Product / Process Change Notification (PCN)

PCN #: PCN_ConUSB2_20220428

Affected Series: WE-ConUSB2;
614004134726,
6140041347261,
614004146826

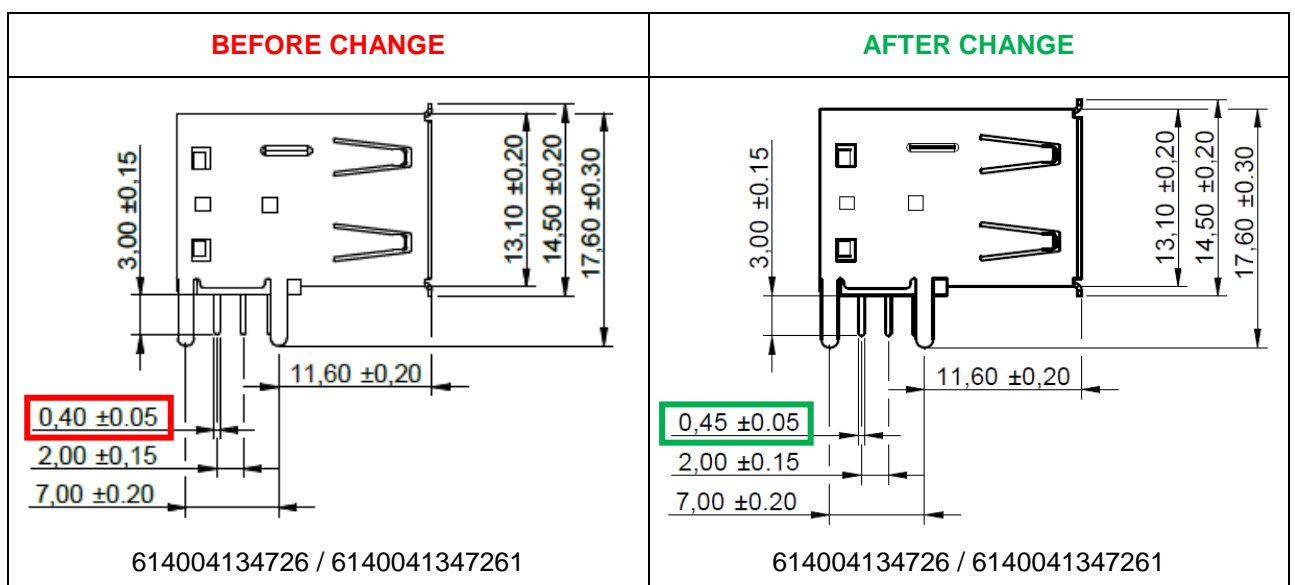
Because of a database mismatch, Würth Elektronik is correcting the datasheet for those 3 part numbers.

This is a datasheet correction only. There will be no change in form, fit, function, quality or reliability of the product.

<p>614004146826</p> <p>Pin thickness : 0.40mm</p>	<p>614004146826</p> <p>Pin thickness : 0.45mm</p>
<p>RELIABILITY / QUALIFICATION SUMMARY:</p> <p>There will be no change of the product, therefore no additional reliability or qualification testing will be performed.</p>
